NOTICE OF PREPARATION OF ADRAFT ENVIRONMENTAL IMPACT REPORT FOR THE WAT KHMER KAMPUCHEA KROM TEMPLE PROJECT

FILE NO: C20-021/SP20-024/ER20-147

Location: 2740 Ruby Avenue, San Jose, CA 95148

RESIDENT'S RESPONSE TO THE: Proposed Rezoning and Special Use Permit at 2740 Ruby Avenue , Project No. C20-012 & SP20-024

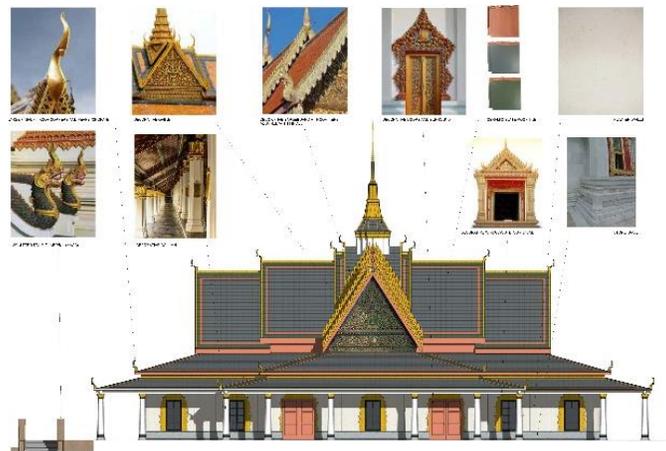
10. A visualization of the proposed temple with respect to the neighborhood, especially the small existing home at 2720 Ruby Ave surrounded on 3 sides by the proposed project, the temple would be **COMPLETELY OVERSIZED**, out of character for this small lot of land. It is also **ESTHETICALLY NON-COMPATIBLE**.

INCONSISTENT - DECEIVING OCCUPANCY CAPACITY

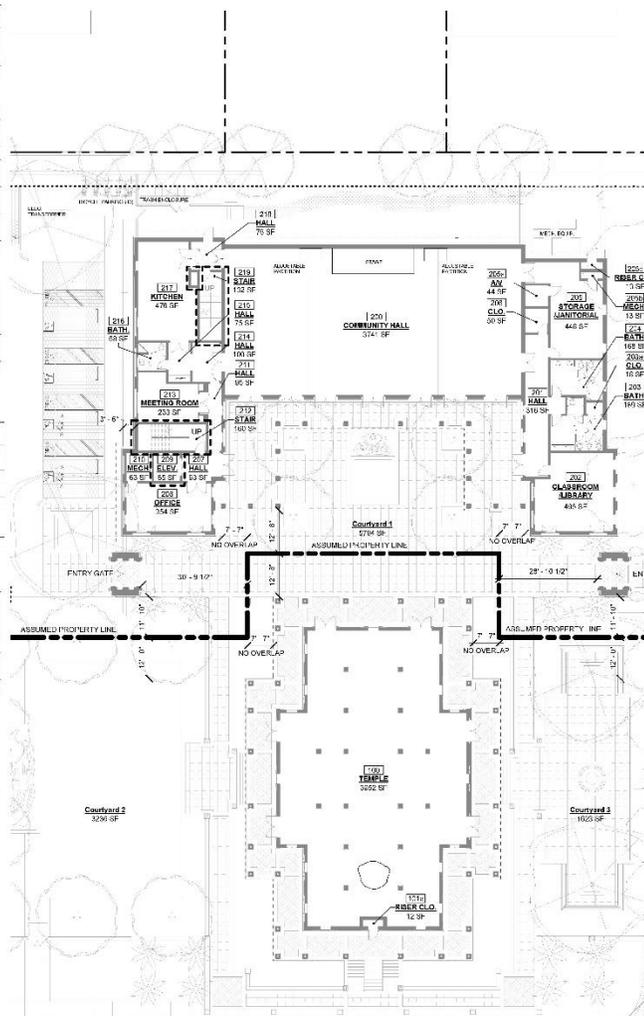
OCCUPANT LOADS REPRESENT BUILDING DEPARTMENT EGRESS ANALYSIS PER CBC TABLE 1004.5 AND DO NOT REPRESENT ACTUAL EXPECTED BUILDING ATTENDANCE.

- 25 visitors weekday, 75 visitors weekend
- Up to only 300 visitor on special event...

FIGURE 1 – Home directly impacted by MASSIVE Driveway, MASSIVE PARKING LOT, MASSIVE 65 feet Tall Building on 3 Sides

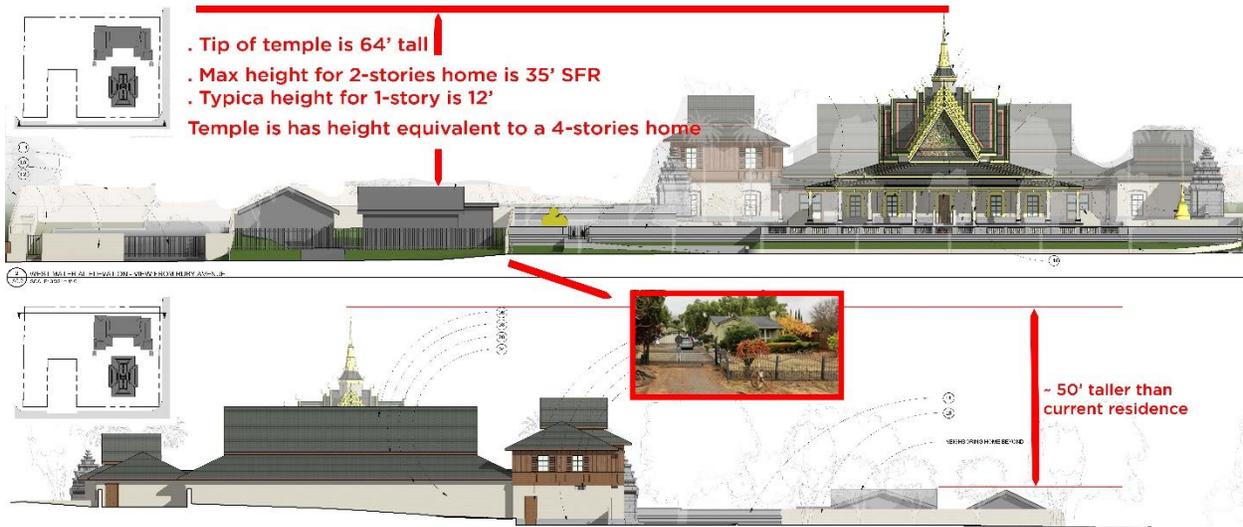
7. Neighbors who are directly next to the projects will be severely impacted! Neighbors in a typical 1500-2500 SF homes will be looking at a **MASSIVE structure** over their fence. The **resident @ 2720 Ruby (See Figure 1)** will be wrapped on 3 sides of their home by a **HUGE entrance into a HUGE parking lot, next to a MASSIVE 65 feet tall building, and GIGANTIC bigger than life garden ornamental scuptures. HOW IS THIS PROJECT COMPATIBLE** within a dense Residential Neighborhood?

8. For every **Council Members**, every **Planning Commissioners**, every member of the **planning staffs**, the **lobbist(s)**, the **designer(s)**, **honestly**, would you approve this project if you are the **resident of 2720 Ruby**, and your home will be surrounded by a **MASSIVE driveway, a MASSIVE parking lot, and MASSIVE building that is 65 feet tall** and all the **MASSIVE yard scuptures** next to your fence?

FIGURE 2 – HOME DIRECTLY IMPACTED has been ALTERED FROM EXISTING APPEARANCE (DECEIVING)

Figure 3 – The project proposes 56 stalls of parking and 15 double-parked spaces that would block 60% of on-site parking stalls. Image is Applicant’s sheet G3.0, “Parking Count Diagram.”

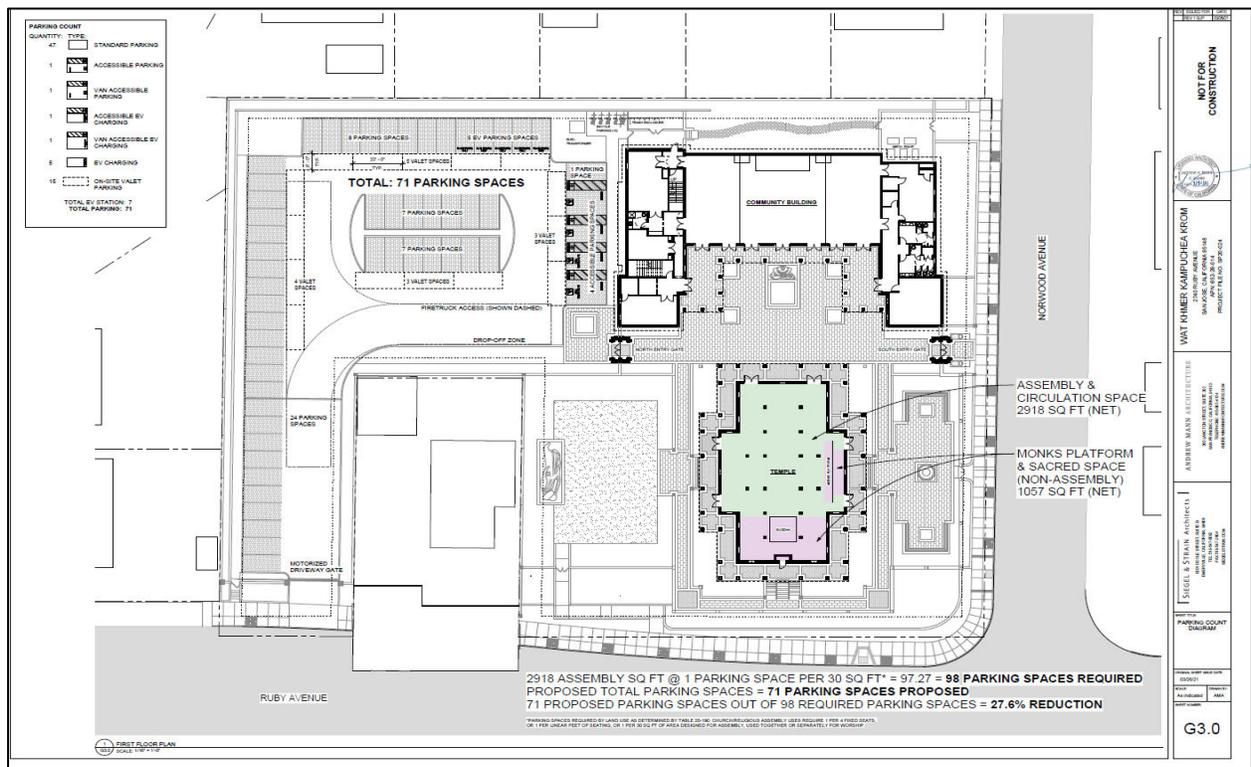
The Proposed Project would provide these 98 parking spaces through a combination of on-site and off-site parking. As shown in Figure 3 below, on-site parking would consist of 56 stalls of parking and another 15 spaces that vehicles would use to double-park. These double-parked vehicles would block 60% of the on-site parking stalls, including stalls dedicated for parking for disabled persons. Though the double-parked spaces are identified as "valet," no permanent valet is proposed to manage daily use of these spaces. All vehicle trips to the Site would occur via one proposed point of access. All loading/unloading would occur within about 15 feet of the rear of the Tran family home.
